CITY PLANNING COMMISSION

- APPLICATION:**
1. Environmental Determination
 2. Lot Line Adjustment to merge two parcels into one 0.4± acre site for parking lot development
 3. Variance to waive six foot solid masonry wall on east property line (Section C-5)
 4. Special Permit to allow a parking lot in the Garden Apartment-Review (R-2A-R) zone (Section 2-B-28)

LOCATION: 1927 and 1929 Wentworth Avenue

PROPOSAL: The applicant is requesting the necessary entitlements to develop a parking lot in a residential zone to accommodate overflow parking during peak hours and provide employee parking for Raley's Market.

EX B

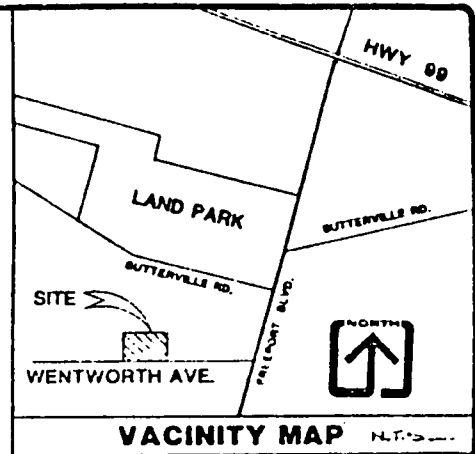
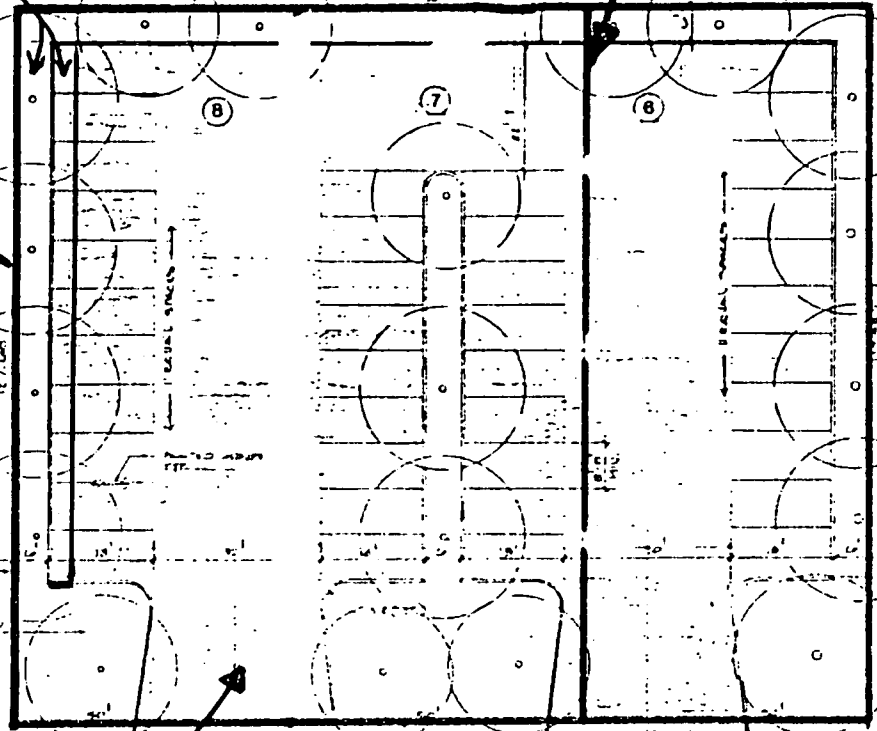
INCREASE
PLANTER
WIDTH
TO
12 FEET

7. Staff has a concern regarding the location of the driveway near the single family residence. Staff suggests the westerly driveway be eliminated and replaced with landscaping. This will locate the parking ingress/egress farther away from the residential area and additional planting will provide a better transition between the residential and parking lot uses (see exhibit C).

8. To increase the buffer along the westerly property line, the six foot planting strip indicated on the site plan should be increased to 12 feet in width. This can be attained by reducing the parking stall depth from 18 feet to 16 feet and reducing the maneuvering space from 30 feet to 26 feet. This planting strip should be heavily landscaped with shrubs and trees (see exhibit C).

- c. The applicant shall eliminate the westerly driveway entrance and replace with landscaping. Revised plans shall be submitted to the City Traffic Engineer and Planning Director for review and approval prior to issuance of building permits.

- d. The applicant shall provide for a 12 foot wide planter strip along the westerly side of the property as indicated in exhibit C. This planter shall be heavily landscaped with shrubs, ground cover and trees.

Exhibit A:

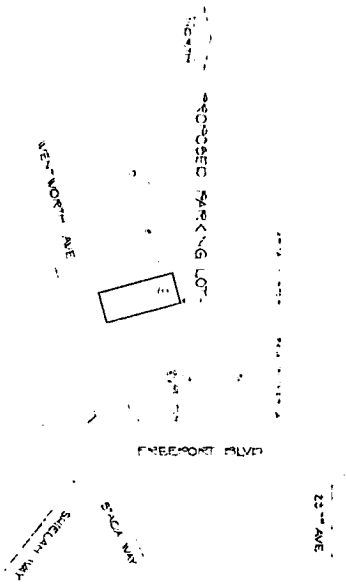
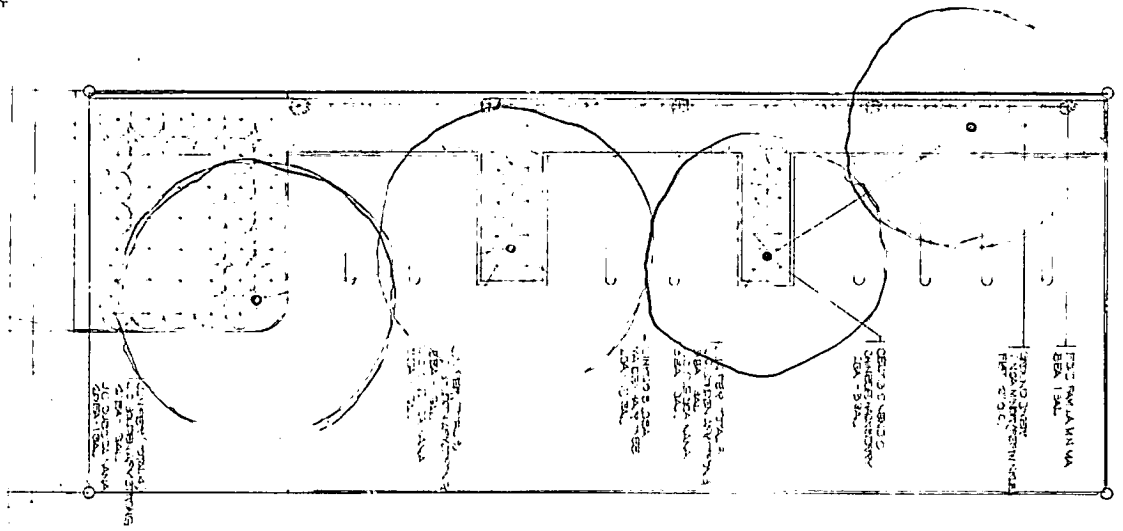
4. Staff is concerned about the adequacy of the proposed landscaping that will abut the adjacent residential property. Staff suggests that two additional trees be provided along the masonry wall (see Exhibit B) to achieve a screening effect between the parking lot and residential development. The three trees should be broadleaf evergreens to assure a year-round effect.
